MEETING MEMORANDUM

Pre-Request for Additional Information Meeting

PROJECT: Project Tiger – Airpark Site
REPORT BY: Parker Osterloh

Attachment 1:
Figure 5: Preliminary Wetlands and
Waters of the U.S. Impact Map
revised 12/12/2019

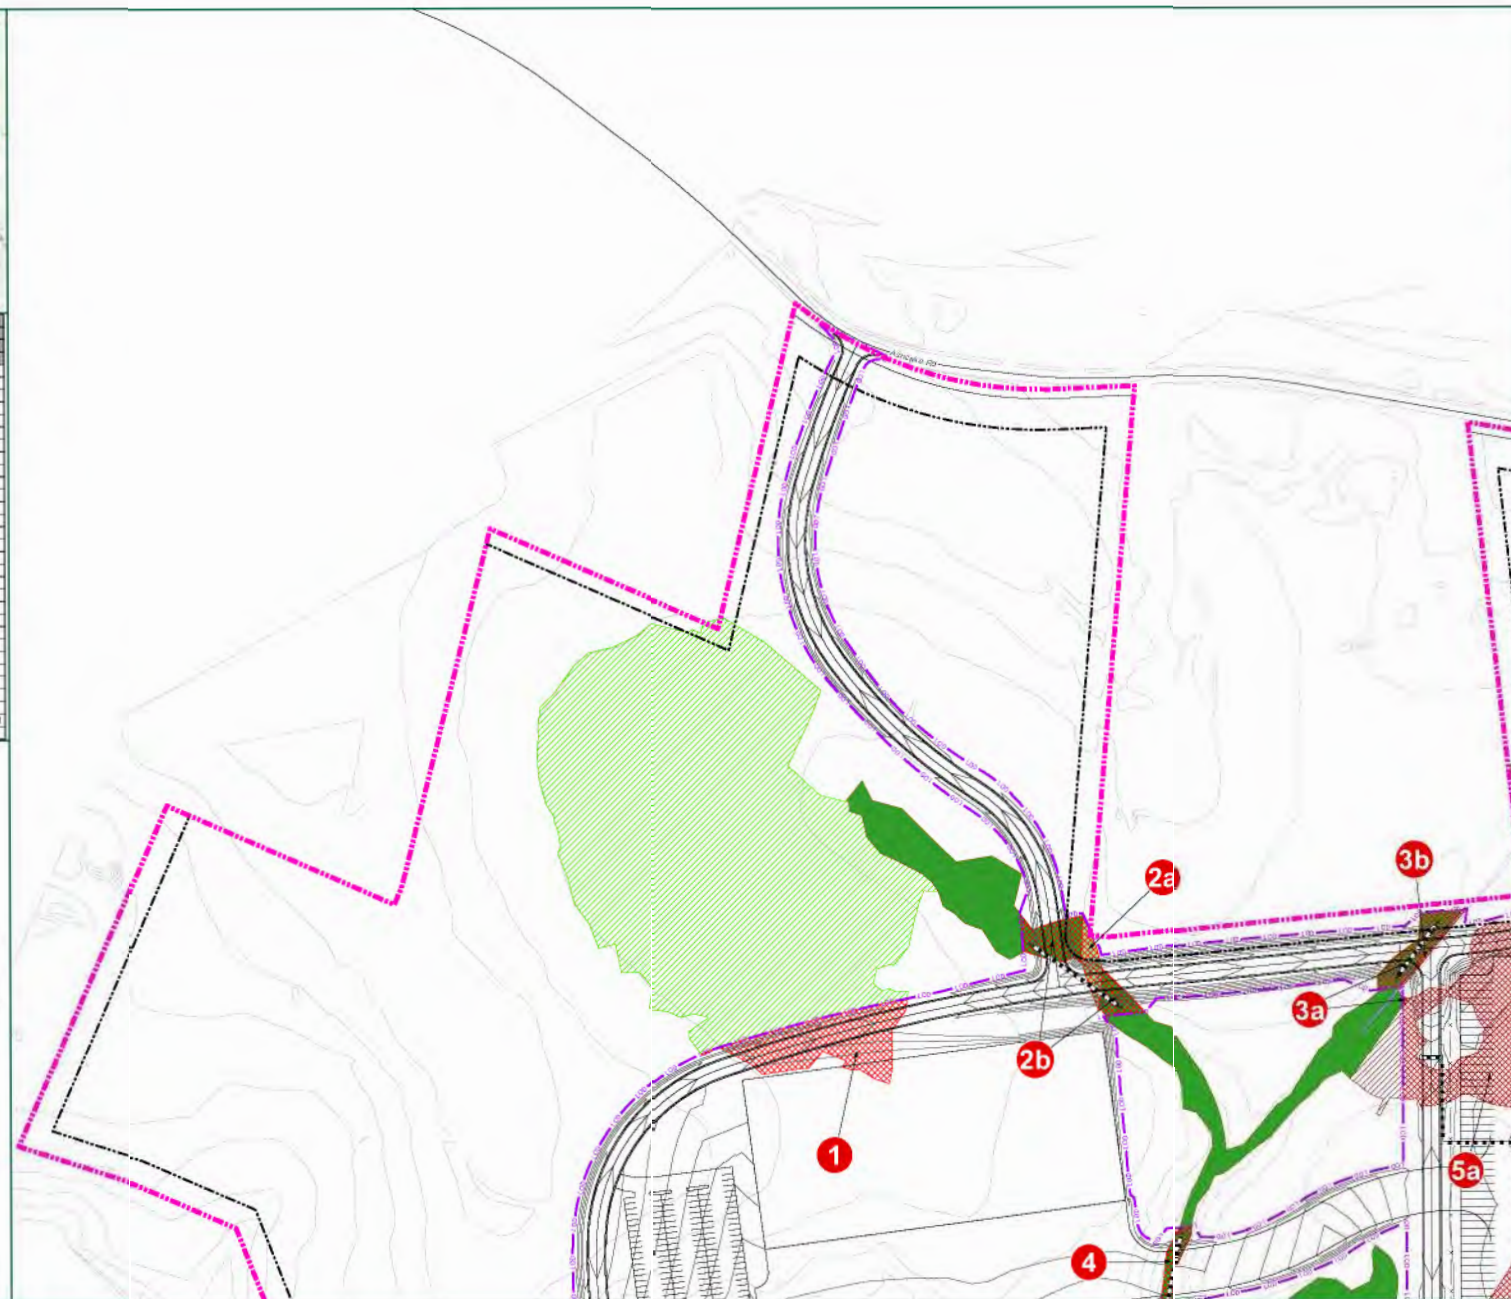
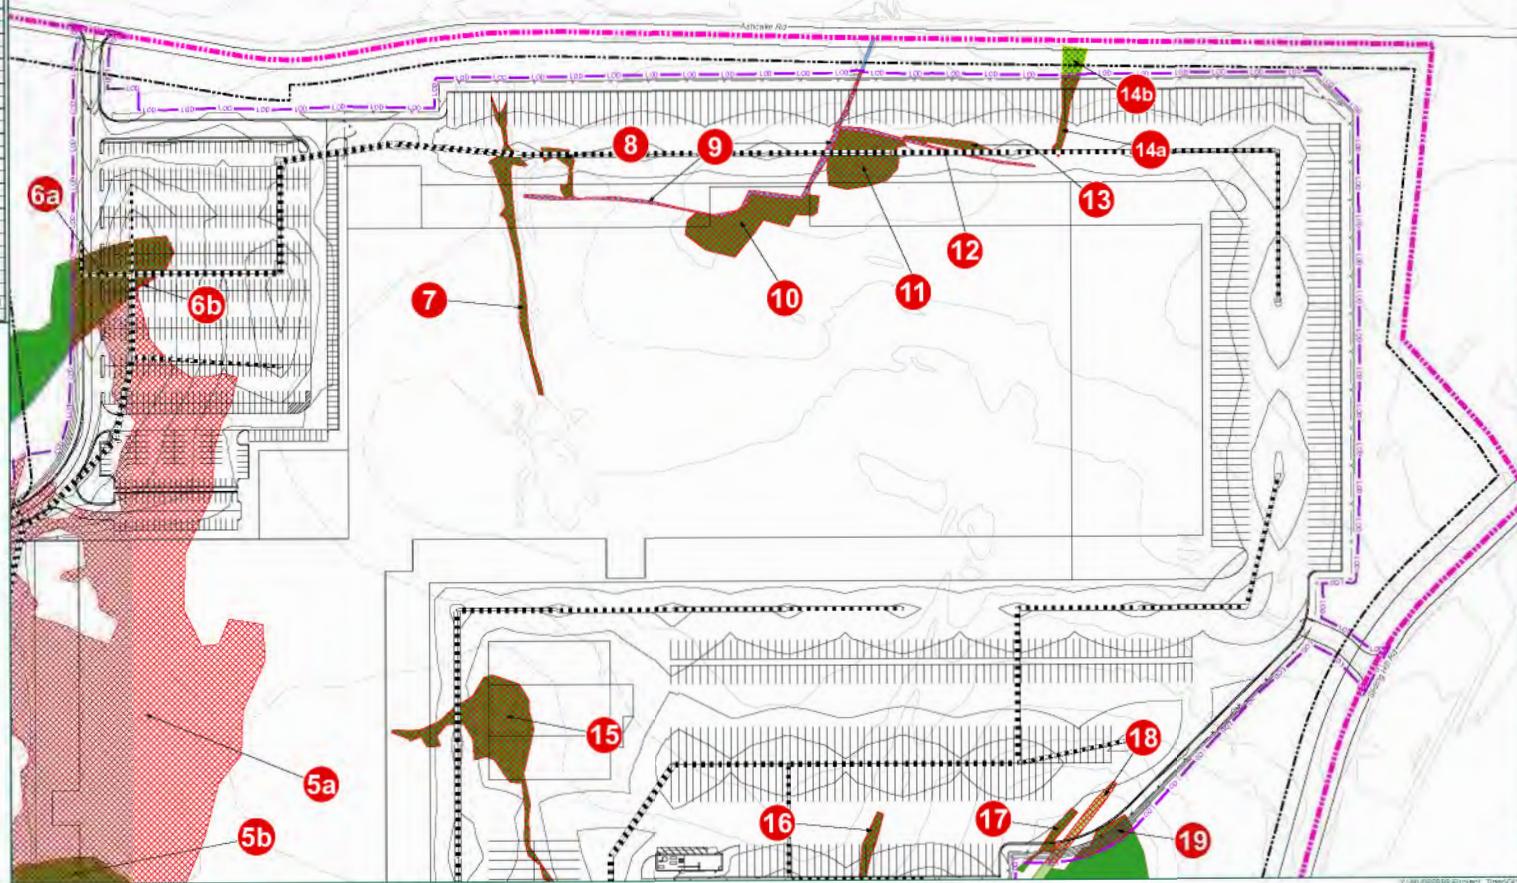
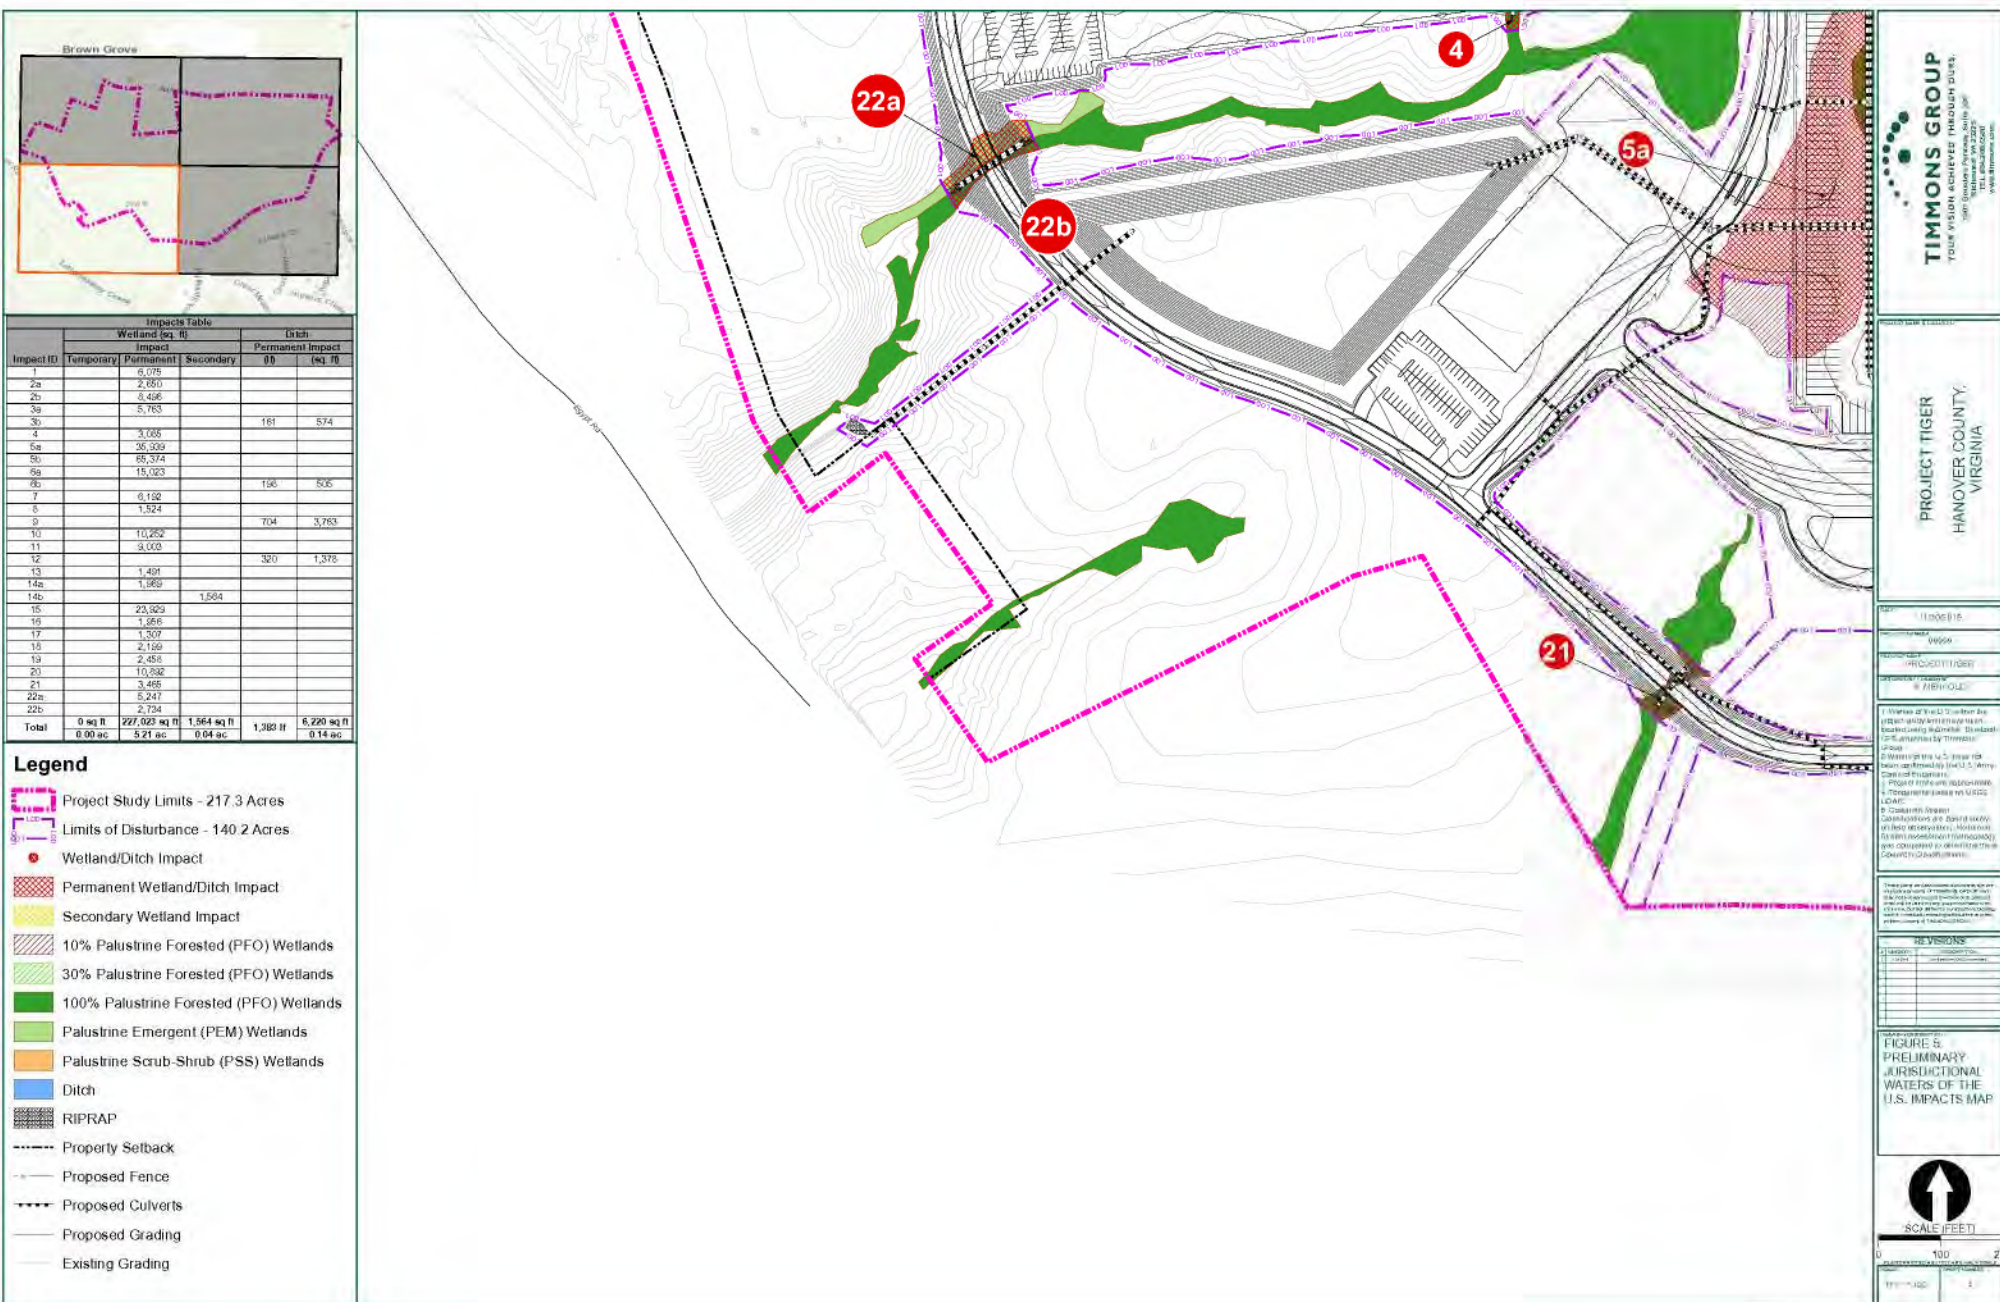
4. **“Figure 5: Preliminary Jurisdictional Waters of the U.S. Impacts Map” dated 11/20/2019 and “Table 2: Wetlands and Waters Impact Information” in the permit application reflect different impact areas for Impact 3a.**

5. **All existing/proposed contours and structures must be displayed on the impacts mapping.**

8. **It appears there may be a secondary impact to the wetlands immediately west of impacts 6a and 6b as depicted on the impact map. Please provide additional information as to why these wetlands would not be secondarily impacted.**

9. Please explain how impact 14 will not create secondary impacts to the wetlands between the pad site and Ashcake Rd?

“Table 2: Wetlands and Waters Impact Information” and “Figure 5: Preliminary Jurisdictional Waters of the U.S. Impacts Map” have been updated to reflect the true Impact area for impact 3a. See Table 2 above and the attached revised impacts map. The required mitigation table has also been updated to reflect these changes. The required compensatory mitigation table has been updated as well. Please see Table 3 below.

All required components of impact mapping have been incorporated into the attached revised impacts map dated 12/12/2019.

Secondary impacts to the wetlands between the developed site and Ashcake Road are unavoidable. The impact map has been updated according. These impacts will be included in the required mitigation calculations as well.

XSEC 3 PROFILE

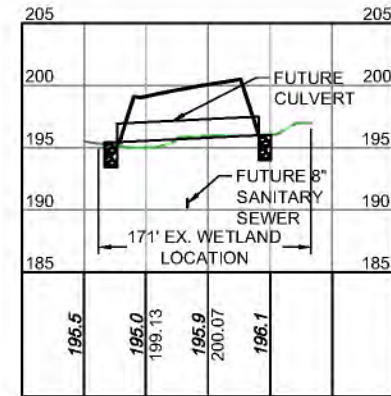
11. How will hydrology be maintained for Impact 3 / cross section 3?

A culvert has been added to impact 3 in order to maintain hydrology between aquatic resources associated with impact 3. This is reflected in Attachment 1: Figure 5: Preliminary Wetlands and Waters of the U.S. Impact Map revised 12/12/2019 and Attachment 3: Revised Cross Section Exhibit.

**Attachment 4:
Confirmed WOUS Map (pending
reconfirmation)**

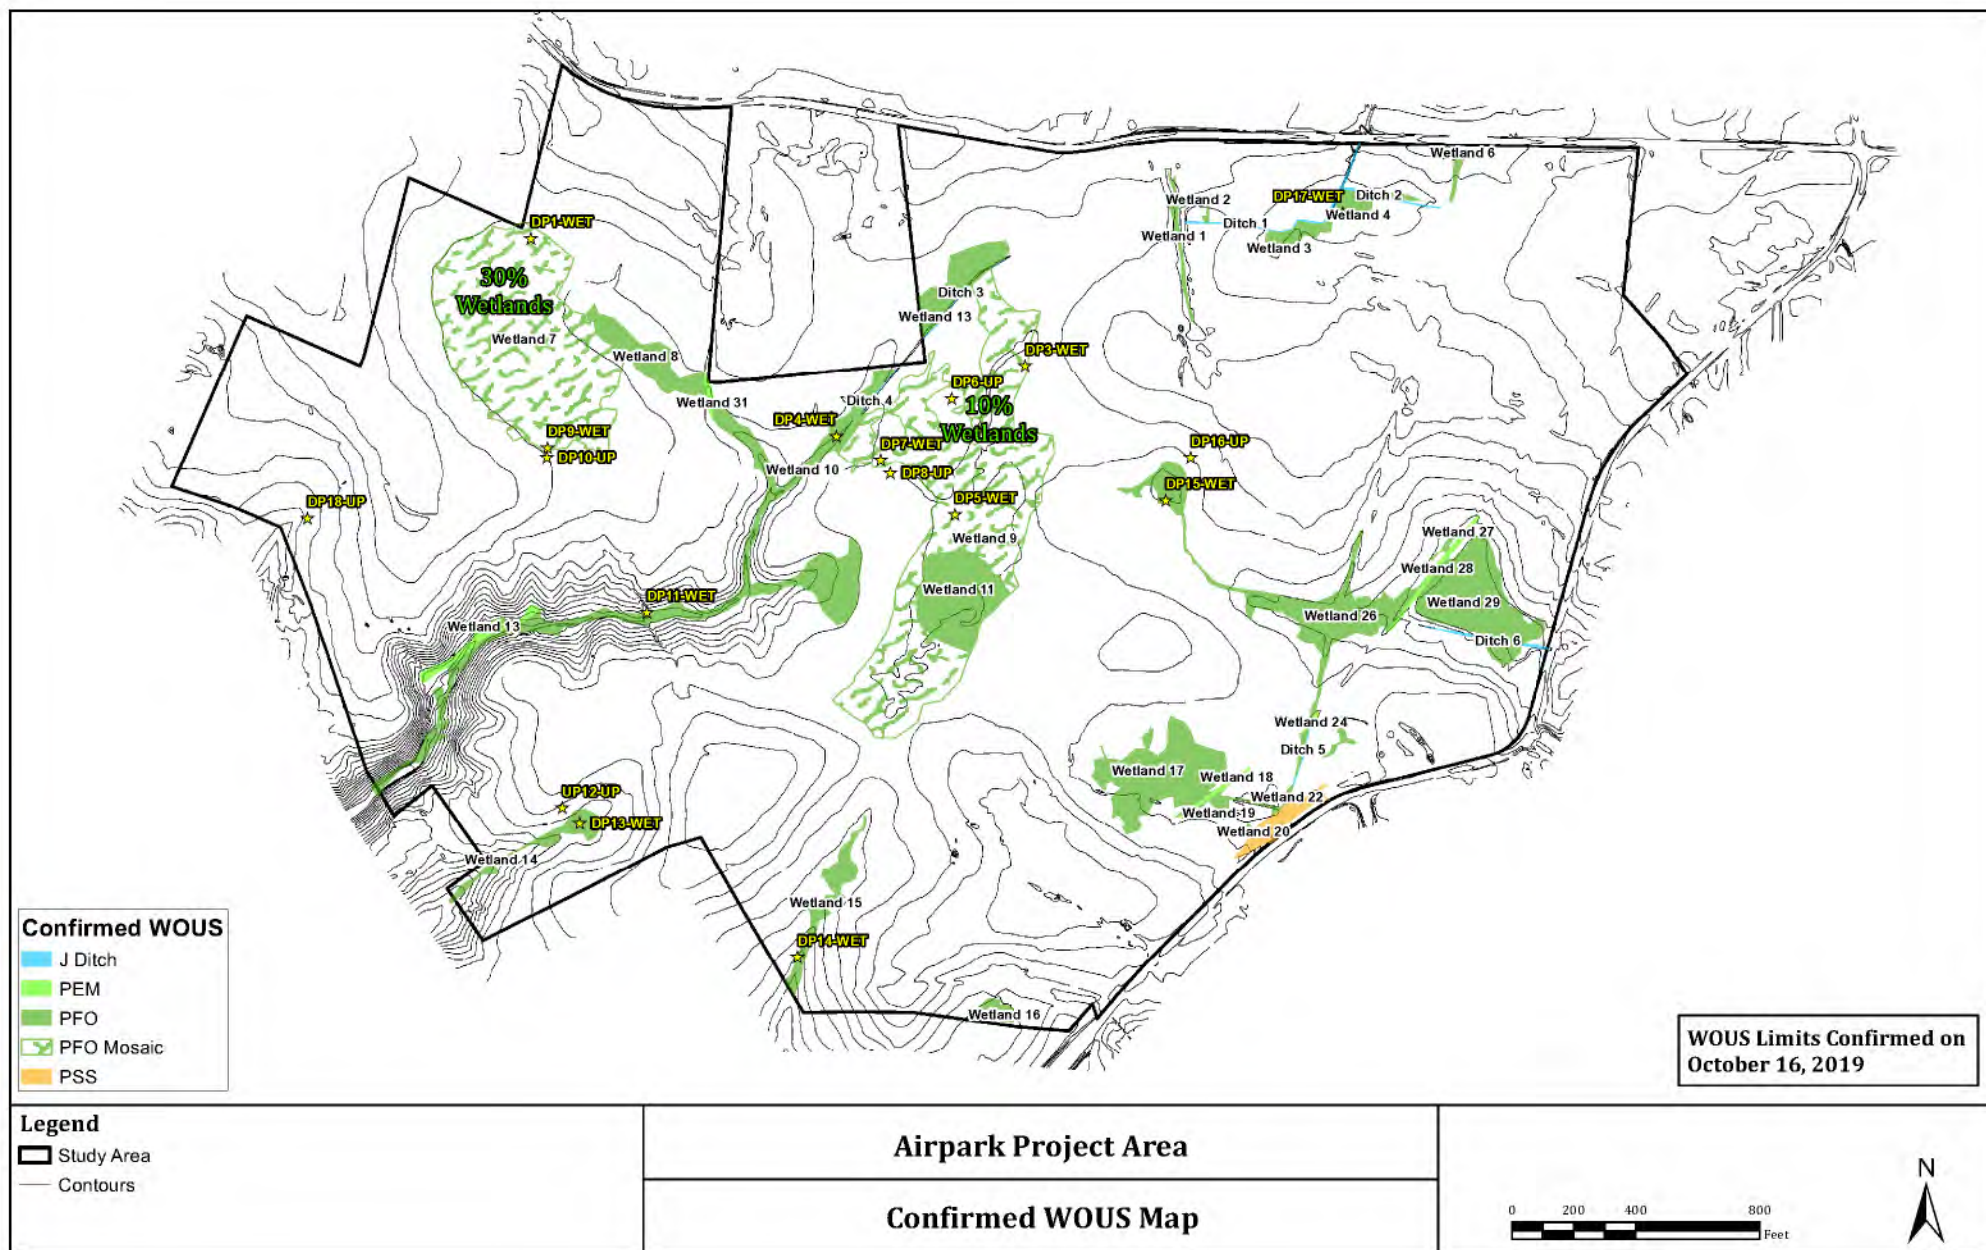
- 1. The Site boundary on the Confirmed Preliminary Jurisdictional Determination Map differ from the Site limits in the remaining project mapping (i.e. impacts mapping and site layouts).**

The consultant who obtained the PJD has submitted a revised map that reflects the correct Site boundary to the United States Corps of Engineers (USACE) regulator who is assigned to the project. The PJD is pending review and confirmation by Ms. Elaine Holley and will be provided once the confirmation process is complete.
